S4.55 LIST OF AMENDMENTS:

MCD2020/0139
BASEMENT
NO 3 RL 11.34

PROJECT
THREE STOREY RESIDENTIAL FLAT BUILDING
WITH BASEMENT CAR PARK AT:

5 COMMONWEALTH PDE,
MANLY, NSW

DRAWING TITLE
SECTION BB
PROJECT
CPM
SCALE
1:100
@A3
STATUS
S4.55
NUMBER
A3.02
REVISION
s4.55a

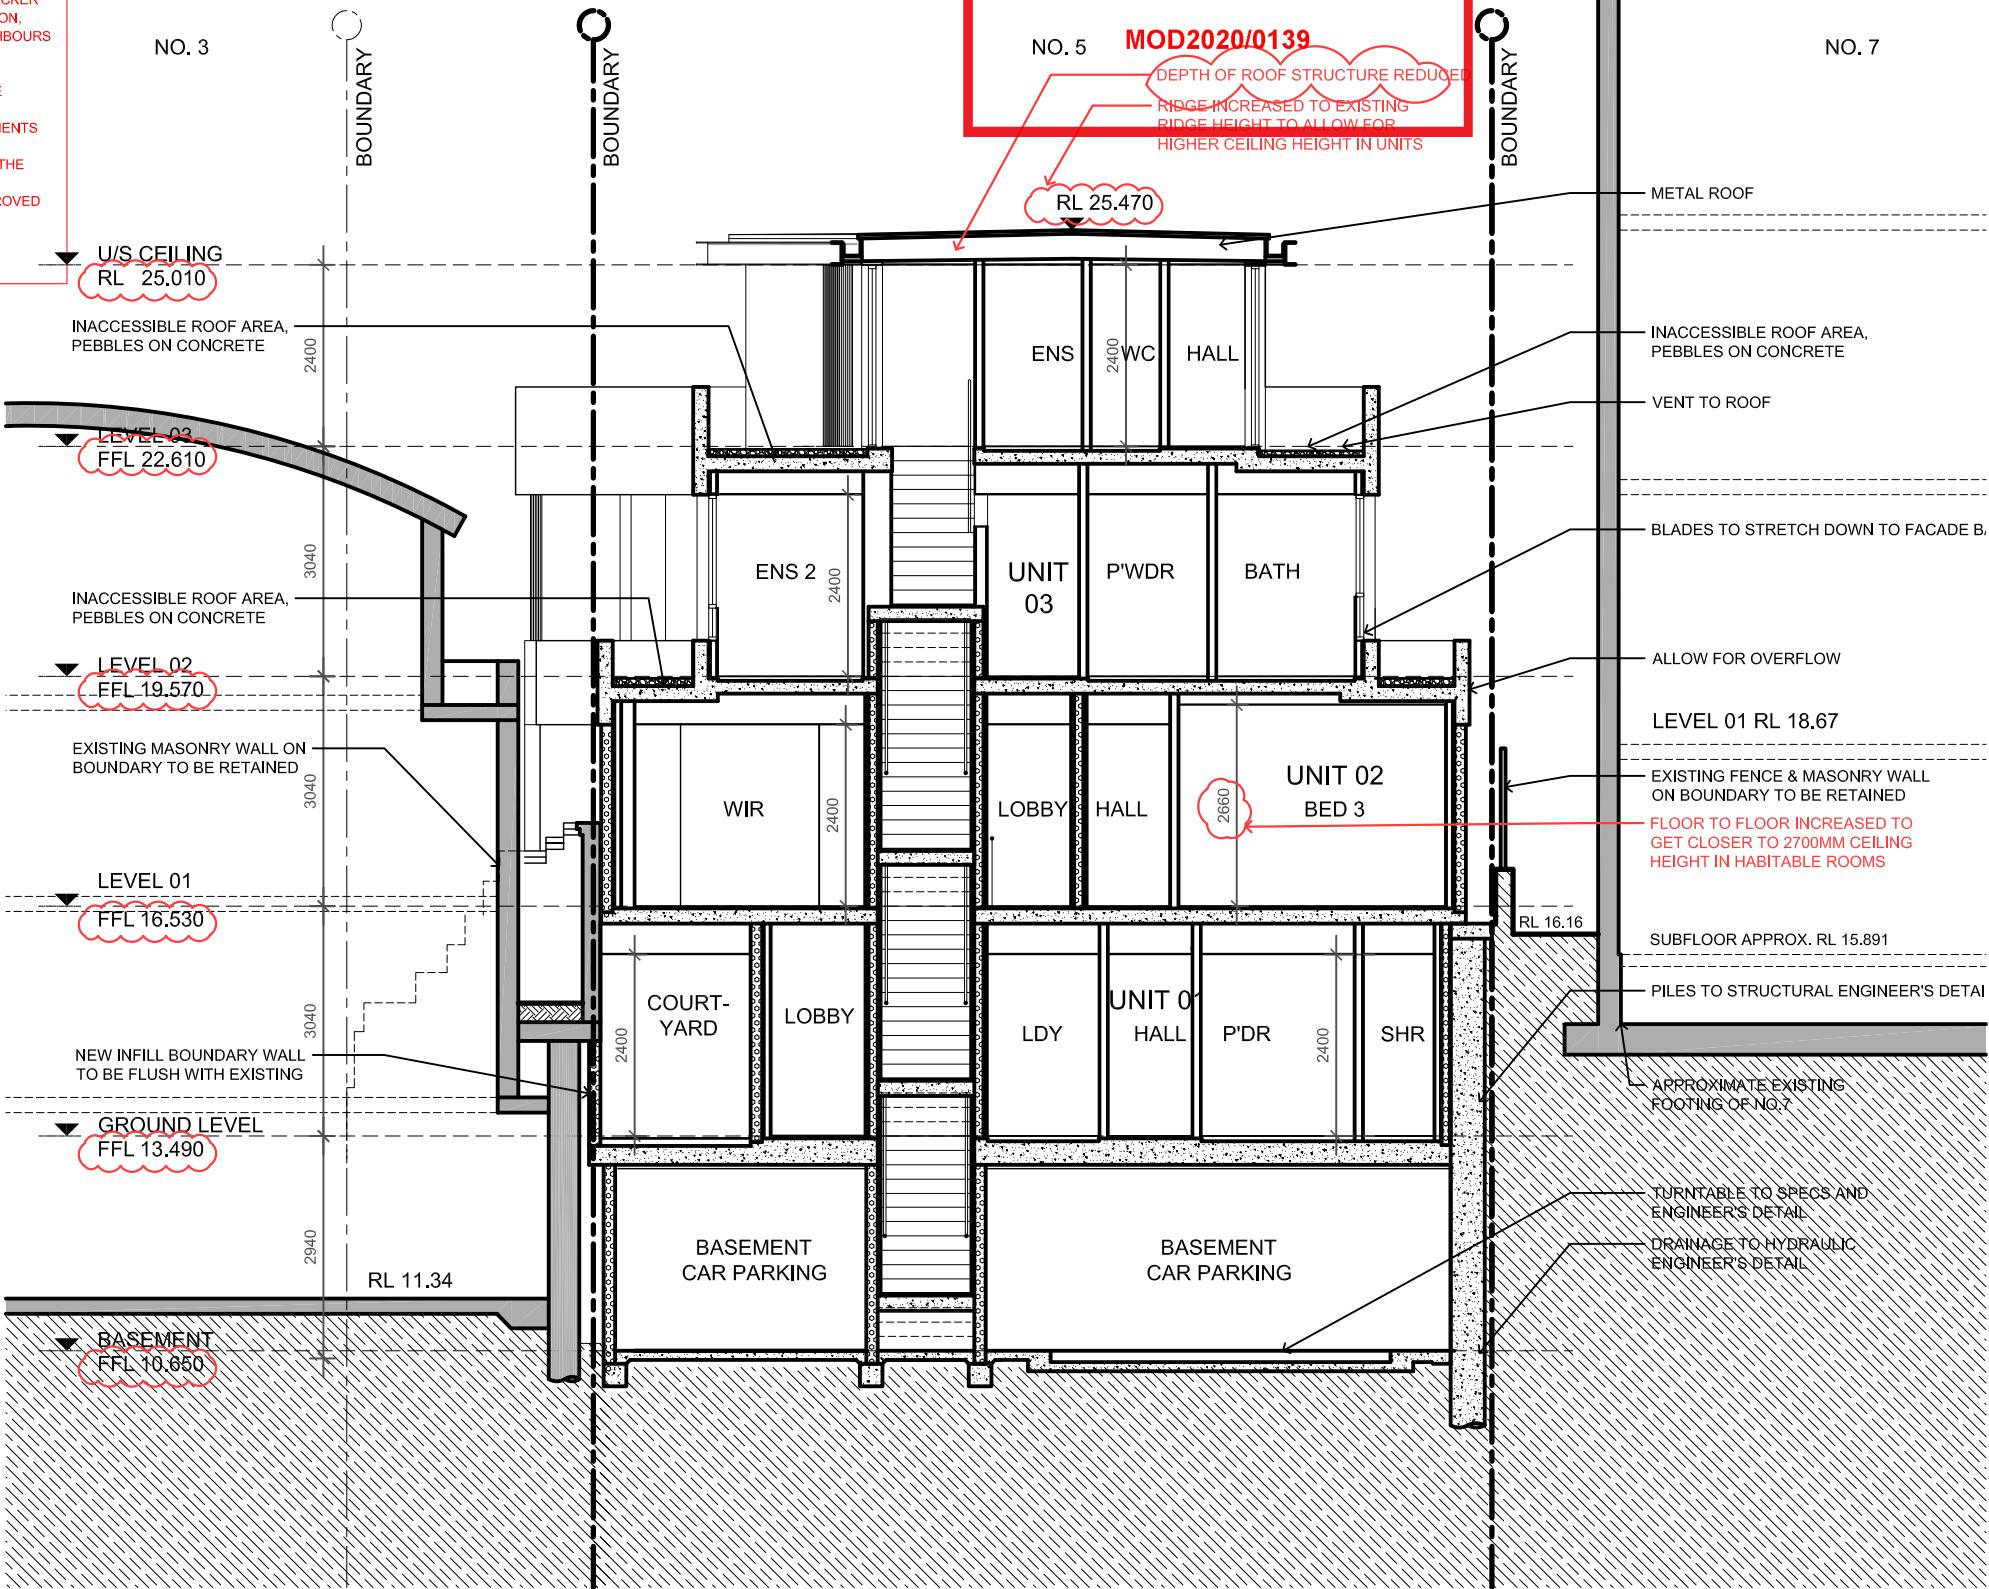
DEPTH OF ROOF STRUCTURE REDUCED
RIDGE INCREASED TO EXISTING
RIDGE HEIGHT TO ALLOW FOR
HIGHER CEILING HEIGHT IN UNITS
